SBN-400
T.F. B7.1.2

References: (a) Construction Permits CPPR-135 and CPPR-136, Docket
Nos. 50-443 and 50-444
(b) USNRC Memorandum, dated October 14, 1982, "Notice of
Meeting Regarding Open Items in the Safety Review,"
L. L. Wheeler to J. D. Kerrigan

Subject: Response to Open Items (SRP Sections 10.3.5 and 10.4.8;
Chemical Engineering Branch)

TABLE 282.2-1

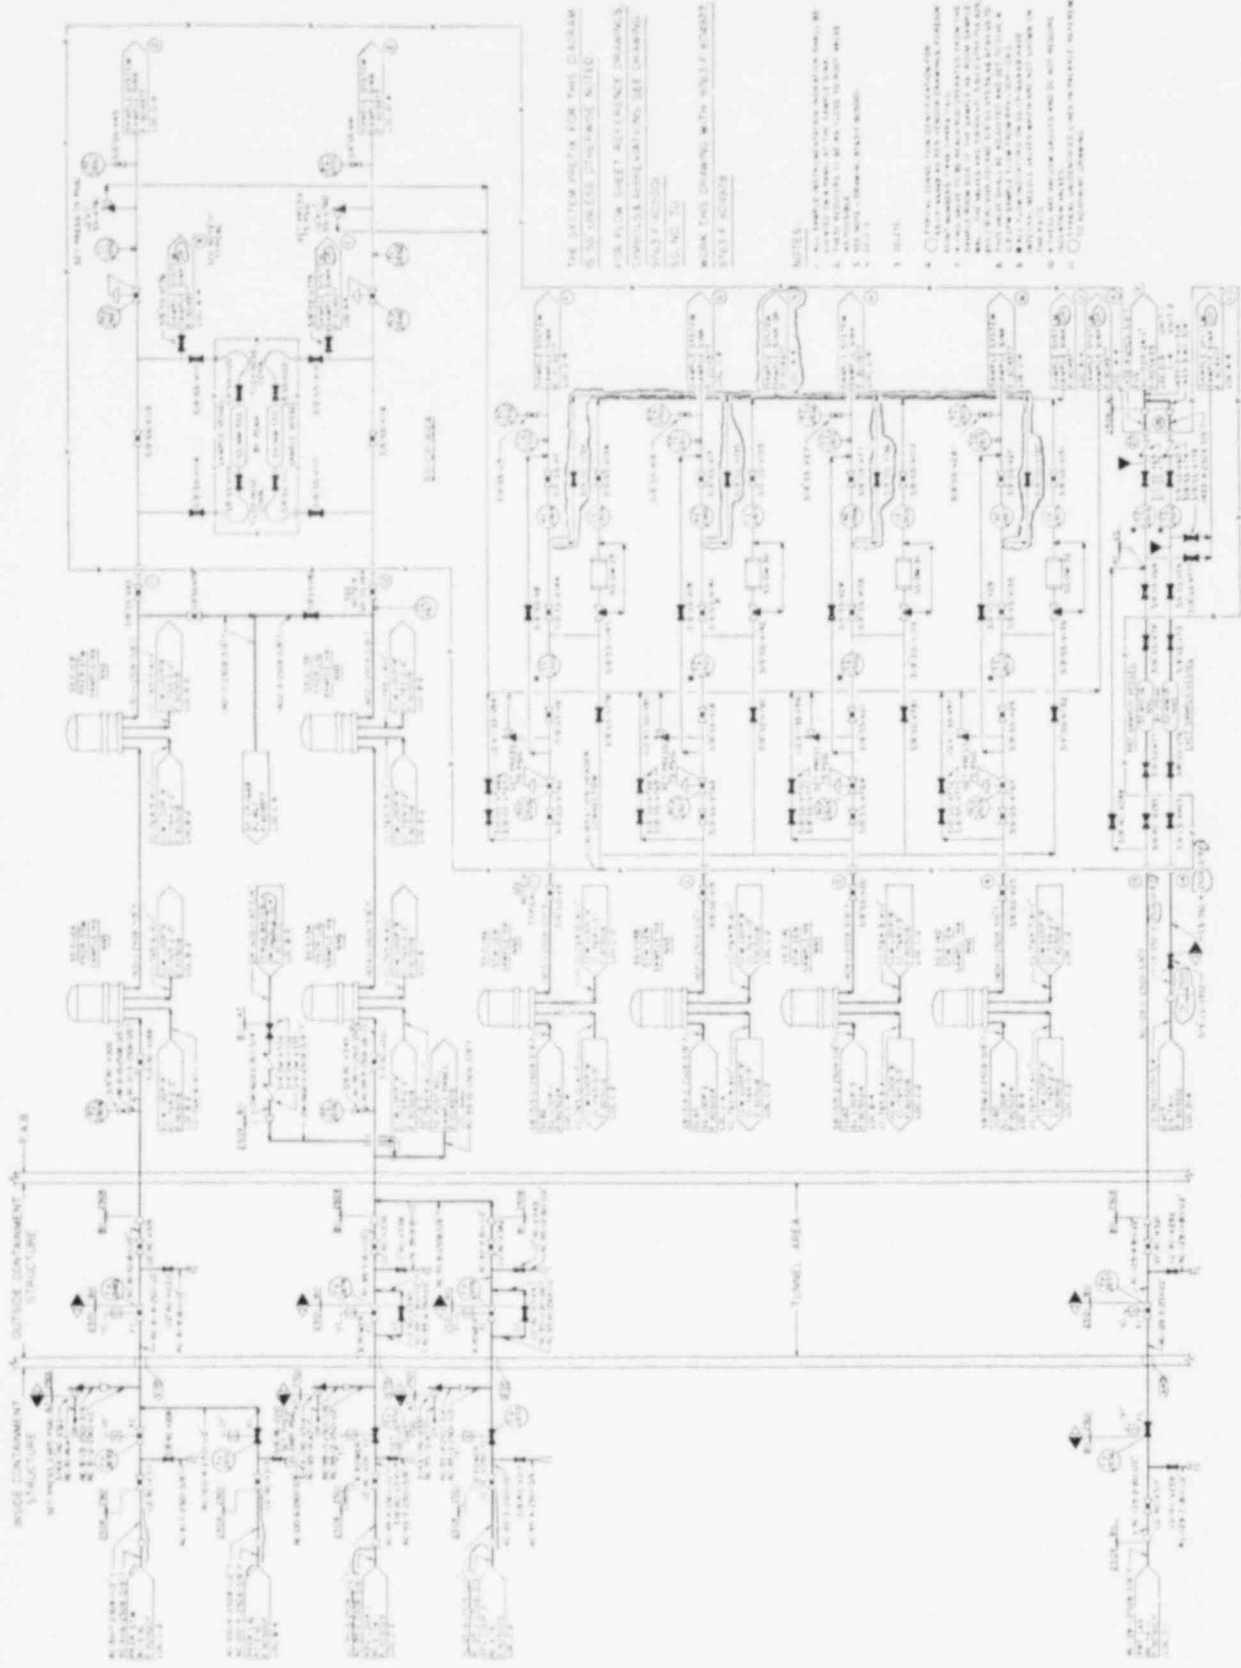
"This program should cover the following operational modes: (1) power operation (normal), (2) startup, (3) hot standby, (4) hot shutdown, and (5) cold shutdown/cold wet layup."

"Each of the above modes should be defined with regards to percent rated thermal power and approximate temperature range, °F."

"The program should include as a minimum the control of pH, cation conductivity, free sodium, and dissolved oxygen. However, other parameters such as specific conductivity, chlorine, fluorine, suspended solids, silica, total iron, copper, ammonia, and residual hydrazine merit consideration."

The critical parameters and specifications for each of the listed operational modes are presented on Table 282.2-1 which was submitted with the PSNH response to RAI 282.2. A copy of Table 282.2-1 is attached. It has been revised to present the information in modes that now match the BTP request.

A copy of Table 282.2-1 (noted above) is attached. It has been revised to provide the thermal power and temperature information requested. This revised Table 282.2-1 will be made part of the next available FSAR Amendment.

The minimum control parameters are included in the program as shown on the attached Table 282.2-1. In addition it should be noted that "free sodium" will be separately monitored, but that the related parameter that is controlled is free hydroxide.

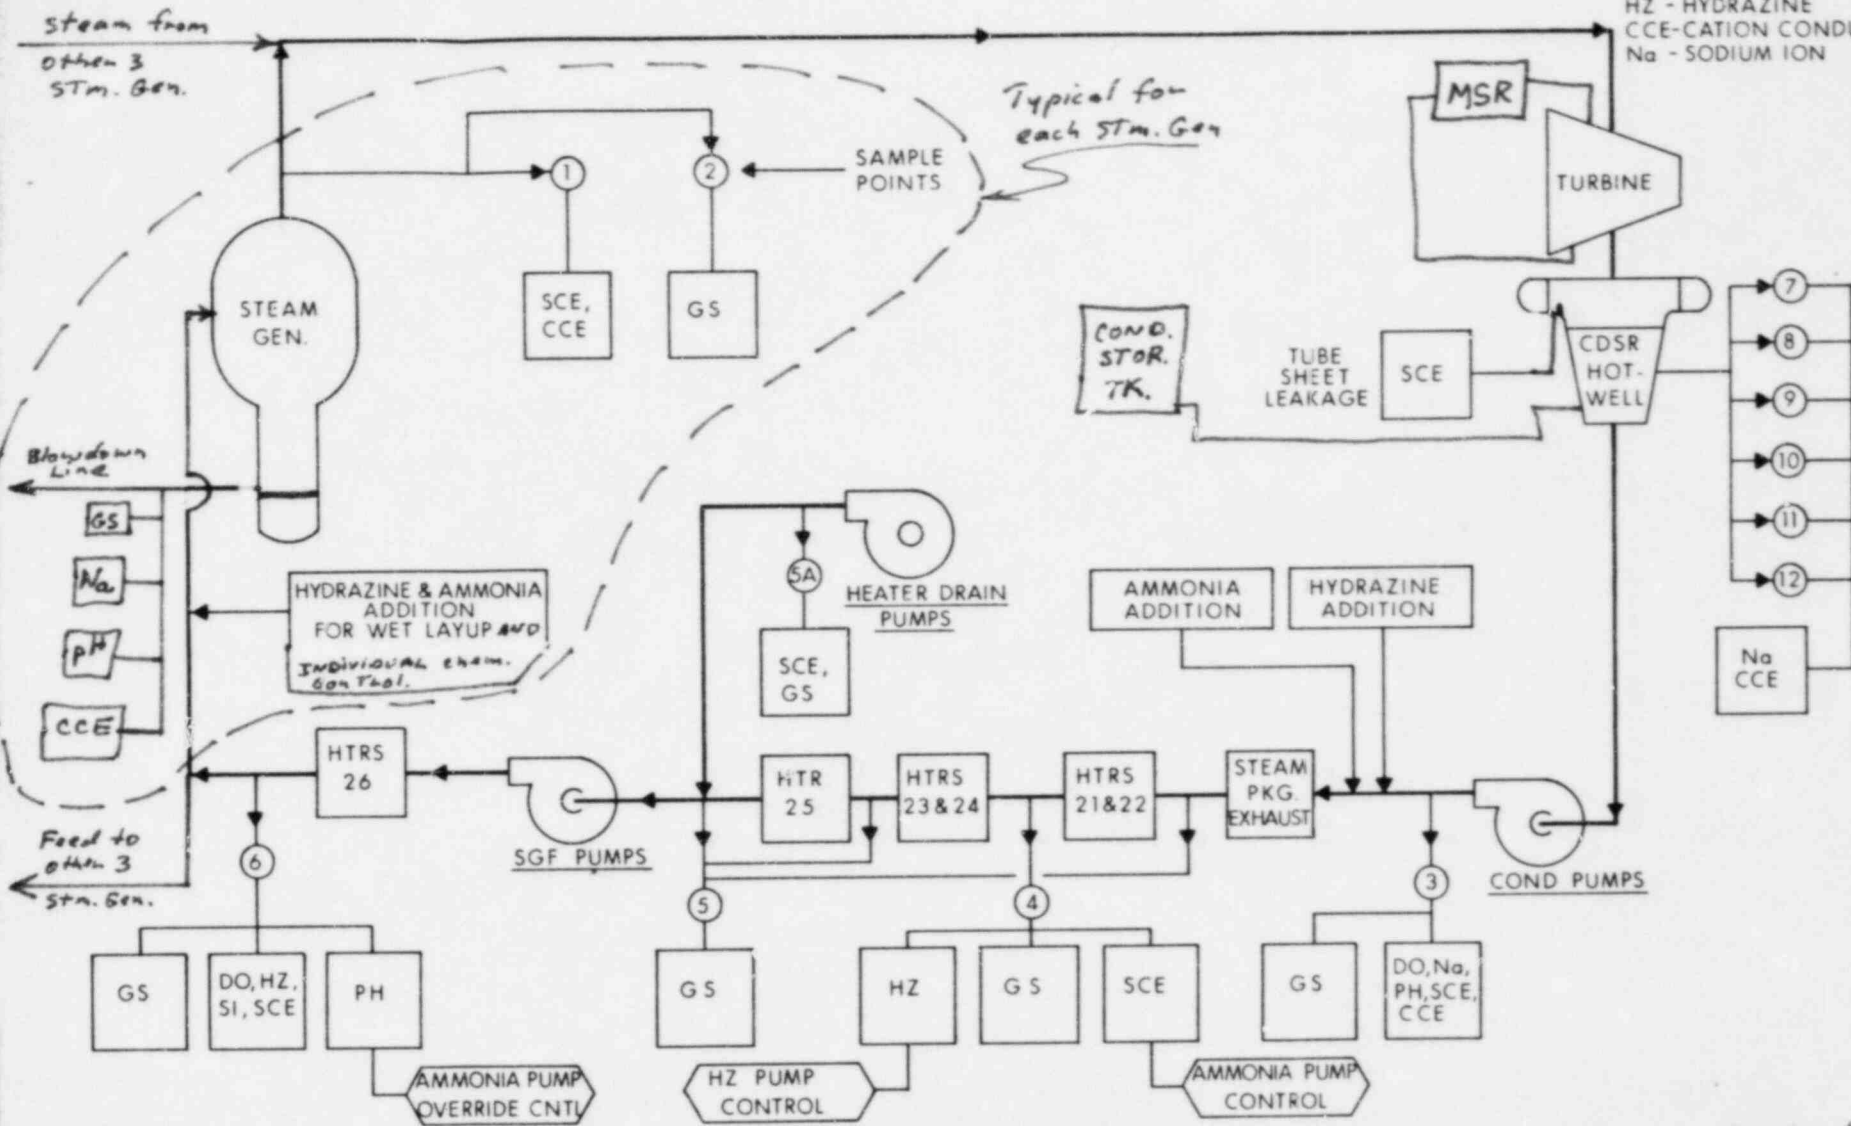
"Assurance should be provided that the sample taken at the blowdown is typical of the bulk steam generator water and that there is a minimum bypass between the feedwater inlet and the blowdown sampling point."

"(3) Identify sampling points. The program should consider sampling the steam generator blowdown, the hot well discharge, the feedwater, and demineralizer effluent as a minimum of sampling points."

"(7) Identify major components of the secondary water system and materials in contact with secondary water coolant."

The components and plant systems that are included in the secondary water chemistry and monitoring program are described in FSAR Section 9.3.2, Tables 9.3-1 and 9.3-2, Figure 9.3-5b, Figure 9.3-6, and FSAR Sections 10.3.5 and 10.4. The attached copy of Figure 9.3-6 has been marked up to display the steam generator blowdown sampling system and the sampling it performs on each steam generator individually.

As shown on the attached copy of revised FSAR Figure 9.3-6 the normal control of the AVT program chemistry parameters, while conducting normal power operations, is performed on all steam generators in parallel. The blowdown from each generator, however, is sampled individually and the chemical addition system provides the capability to adjust the chemistry of any individual steam generator, should such a need arise.

The electrical conductivity and pH of the bulk steam generator water (blowdown) and feedwater is measured continuously as outlined in FSAR Sections 9.3.2.2 and 9.3.2.5 and FSAR Table 9.3-1 and as shown on the attached copy of revised FSAR Figure 9.3-6.

The sampling points include those given in the BTP and are as discussed in FSAR sections 9.3.2 and 10.3.5., the PSNH response to RAI 282.2, FSAR Table 9.3-1 and revised FSAR Figure 9.3-6 (attached). The demineralizer effluent is also sampled even though it is not specifically noted or shown in the referenced material.

The major components of the secondary water systems are shown in revised Figure 9.3-6 (attached). The materials within these components and the interconnecting piping of the condensate, feedwater and main steam systems will be identified and submitted to the NRC in the near future.
